**Response to reviewers' comments on manuscript bg-2016-49 ("Variations in triple isotope composition of dissolved oxygen and primary production in a subtropical reservoir") by Jurikova H., T. Guha, O. Abe, F.-K. Shiah, C.-H. Wang and M.-C. Liang**

**Reply to comments by reviewer #1**

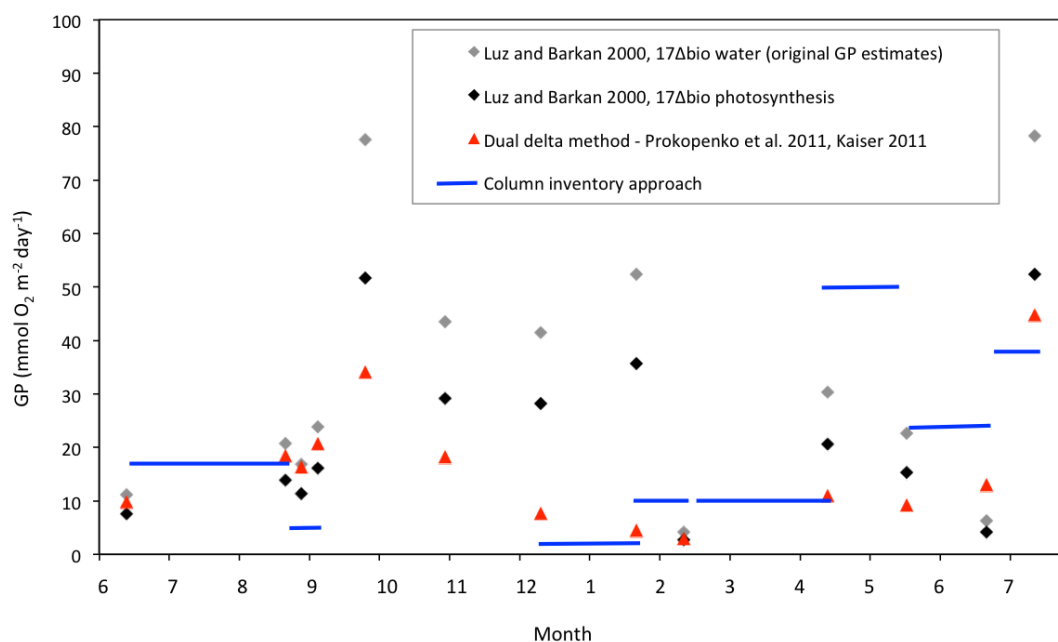
*1) The definition of mixed layer depth used by the authors is provided. This is a very relevant concept because it defines the physical limit for the NP and GP estimations based on O<sub>2</sub>/Ar and triple oxygen isotopes. Consideration of vertical transfer for GP and NP calculation cannot be neglected. Furthermore, in the way is given now, it makes totally irrelevant the calculation of GP since Feitsui Reservoir seems to have a complex vertical and horizontal water structure.*

To assess the relevance of mixed layer model for estimating GP by isotope mass balance calculation, we test an alternative mass balance model based on the column inventory approach (onwards referred to as column inventory approach). Unlike isotope mass balance limited to the the mixed layer, the column inventory model requires time-series data of full profile from the surface to the bottom of the lake, but is able to obtain GP below mixed layer, which occurs when depth of photic zone is below the bottom of mixed layer, without steady-state assumptions.

Fig. 1 shows the results obtained by the column inventory method as well as by mixed layer methods. By comparing blue lines with red diamonds, these are in agreement each other, except for late spring in 2015. This may indicate that the mixed layer model could be valid in the Feitsui Reservoir, not only in the open ocean stations.

Based on this we have made amendments to the manuscript; we have included the column inventory approach interpretation and compared the results between the different methods. A more thorough description on the mixing in the Feitsui reservoir is also made.

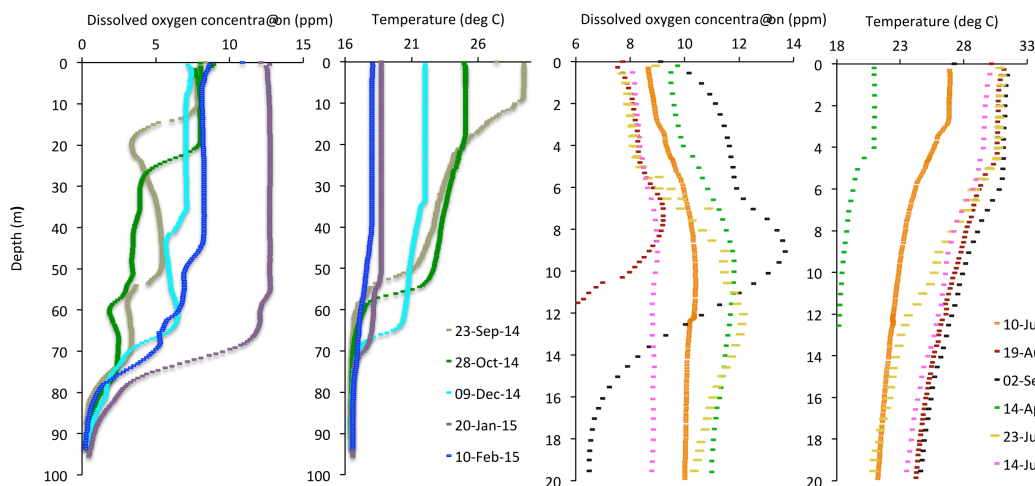
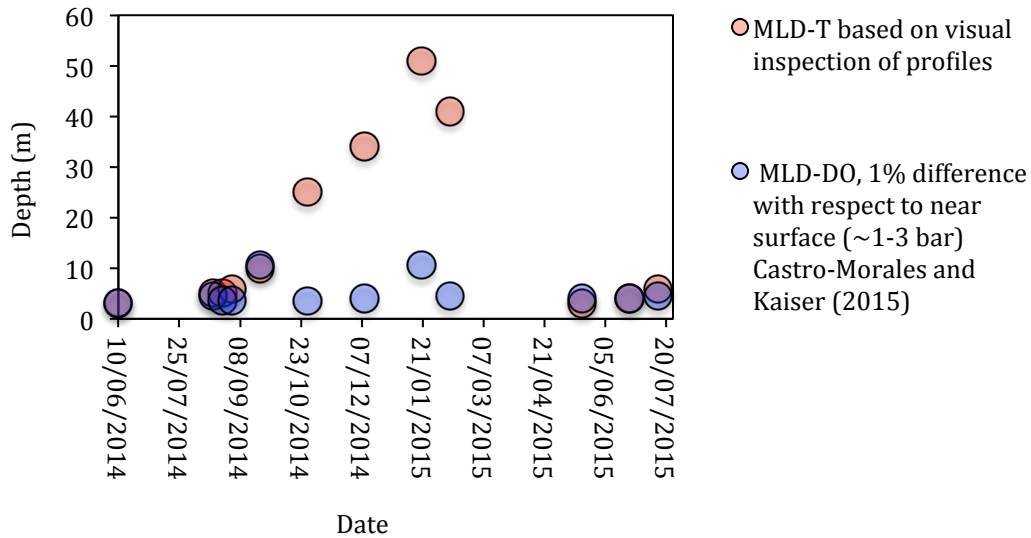
*There is no place in the manuscript in which the authors mention their chosen criteria*

*to define their mixed layer depth. It seems it follows nicely the Chl a vertical distribution in Fig. 2b, but this might be only an artifact of the colors in the figure. Whichever criteria the authors chose to define their mld seems just wrong and not necessarily useful for the observations in  $^{17}\Delta$  values and estimation of mixed layer-GP. The timescale of processes that influence the vertical mixing in lakes and reservoirs depends on the basin size and stratification. I think here it is more complex to define a mixed layer depth that suits to the concept of the estimation of GP from oxygen isotopes. There seem to be a permanent and a temporal mixed layer, with overturning and convective cooling occurring at faster orders of magnitude than what can be estimated with a standard calculation for the gas exchange coefficient. The vertical displacement of primary producers and adaptation should be evaluated and taken into account together with the stable isotopes data. The mld definition for applications of GP from oxygen isotopes and NP from  $O_2/Ar$  ratios must represent closely the metabolic state of the water column within the productive zone. A definition based on oxygen as done in Castro-Morales and Kaiser, 2012, could potentially help to define a better mld for GP and NP estimates based on oxygen measurements.*

The mixed layer was determined based on visual inspections of vertical temperature profiles. We opted for this method to ensure the homogenous epilimnion only is considered as the mixed layer without influences from the thermocline.

We appreciate the suggestions for an improved definition of the mixed layer. In the figure below we compare our mixed layer definition (hereafter MLD-T) and the “1% difference with respect to near surface (~3 bar)” (MLD-DO) from Castro-Morales and Kaiser (2012). Although Castro-Morales and Kaiser (2012) conclude the “0.5% difference with respect to 10 dbar” definition is a more optimal choice in their study, it may not be suitable for subtropical lakes, where the summer stratification often takes place above the reference depth of 10 dbar and therefore could result in overestimating the mixed layer depth. Both, the MLD-T and the MLD-DO show a very close agreement for the summer months. From October to February the MLD-DO tends to underestimate the mixed layer, likely as a result of oxygen variations that are slightly higher than 1% with respect to the reference depth 3 dbar. Nonetheless, as we show in the figure below with vertical profiles of temperature and dissolved oxygen concentration, the same mixed layer depth result may be obtained from visual assessment of the temperature profiles as well as the dissolved oxygen concentration profiles. The thermal stratification of the reservoir must therefore be representative of any changes in dissolved  $O_2$  in the water column. We have now clarified the mixed layer definition in the manuscript.

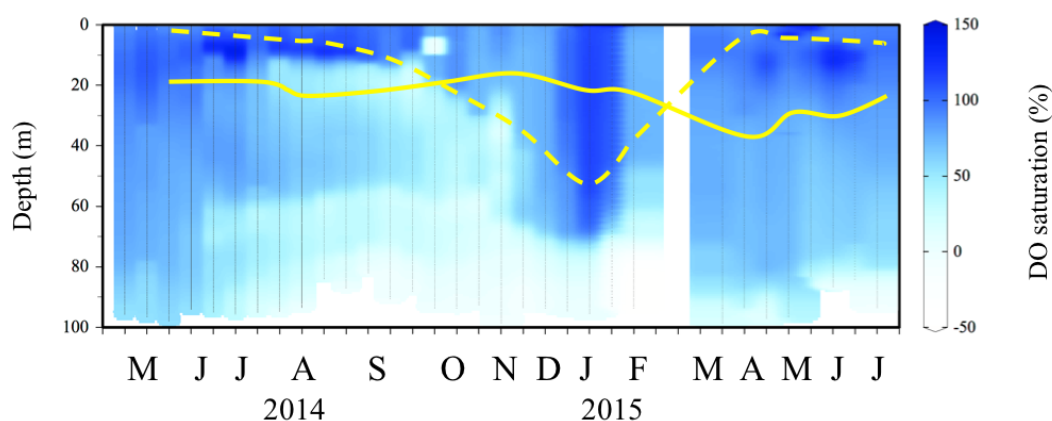
Besides: calculating GP from  $^{17}\Delta$  should be avoided. This was the standard calculation and the approximation may be still fine for low, typically oceanic  $^{17}\Delta$  values. However, higher values will lead to a larger error in the GP, to avoid this, GP should be instead calculated from the measured  $\delta^{17}\text{O}$  and  $\delta^{18}\text{O}$  as demonstrated by Prokopenko et al., 2011 and Kaiser, 2011. Since this are lake samples and some of the results show high  $^{17}\Delta$  values, the authors should consider re-calculating their GP using directly the  $\delta^{17}\text{O}$  and  $\delta^{18}\text{O}$ , but this should be done only if the authors find an agreement on defining a mixed layer adequate to the fast changes occurring in the water column of the reservoir. Furthermore, the presentation of  $^{17}\Delta$  is a better practice in this case and should be presented and discussed in the manuscript as a proxy variable of GP.

We have recalculated the GP based on the  $\delta^{17}\text{O}$  and  $\delta^{18}\text{O}$  values of dissolved oxygen measurements following the dual delta method by Prokopenko et al. 2011 and Kaiser 2011. For comparison, we also included the GP rates from  $^{17}\Delta$  (the Luz and Barkan 2000 approach). We now observe a significant decrease in the GP rates, in particular during the winter months (see the Fig 1. in reply #1) comparing to the GP estimates

from  $^{17}\Delta$ . Moreover, the dual delta GP rates are in agreement with the results from the column inventory approach. These results, not only show the extent of the error due to the use of the  $^{17}\Delta$  approximation instead of the dual delta method, but also confirm the robustness of the mixed layer method for Feitsui reservoir. We have amended this in the revised manuscript; we now use the dual delta method for calculation of GP rates, but also present a comparison between the approaches. Although no longer used for the calculation of GP rates, we expanded the discussion on the  $^{17}\Delta$  as a valuable proxy and tracer of photosynthetic  $O_2$  alone.

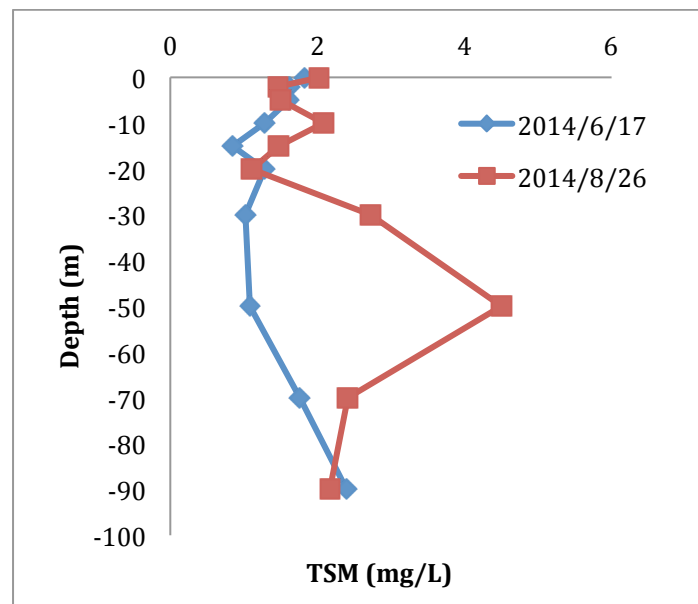
*Which physical processes (horizontal or vertical transfer) occur in the reservoir for the productivity to increase in July at depth? How relevant here are seiches? Was that specifically evaluated?*

Seiches were never evaluated in the Feitsui reservoir and to investigate them is beyond the scope of our present study; however, we would like to stress the importance of considering these phenomena in future studies to understand their role in distribution of gases and nutrients in the water column in the Feitsui reservoir. Alternatively, intrusion of surface water to about 50 m depth can also be supported by dust loading, where we see an increased amount of total suspended material (TSM) concentration (please see in the figure below). This intrusion however occurs at upstream tributaries at distance far away from the reservoir, resulting in rather uniform horizontal profiles across the reservoir reported earlier, for example, by Kuo et al. (2003).

The physical forces that cause vertical mixing in the reservoir include instabilities caused by heat losses at the surface, wind stress at the air-water interface, and instabilities caused by shear at the thermocline. In JUL15 a typhoon Chan Hom closely affected the reservoir area, likely enhancing the vertical transfer (seen from dissolved O<sub>2</sub> saturation and  $\delta O_2/Ar$ ) and elevating primary production.
